PRODUCT CHANGE NOTICE

Original Equipment Industries

Change Notice No. 207

Component Product Title: Grazie/Sitka seating line. All models.

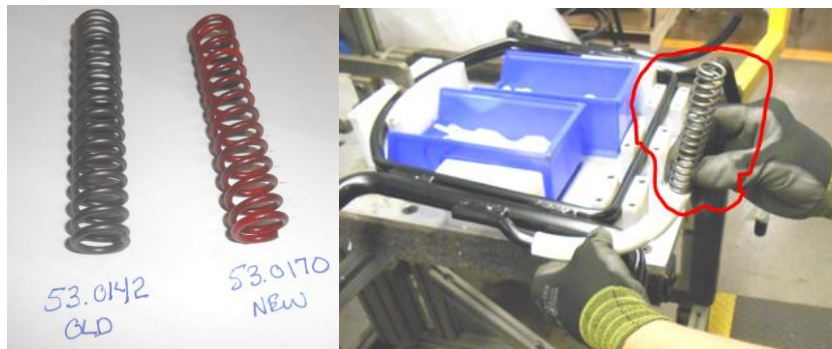
Description of Change: Back spring change from part number 53.0142.X to **53.0170.X**. The new **53.0170.X** spring will be colored **RED**.

Reason: Customer requests for more tension on back flex.
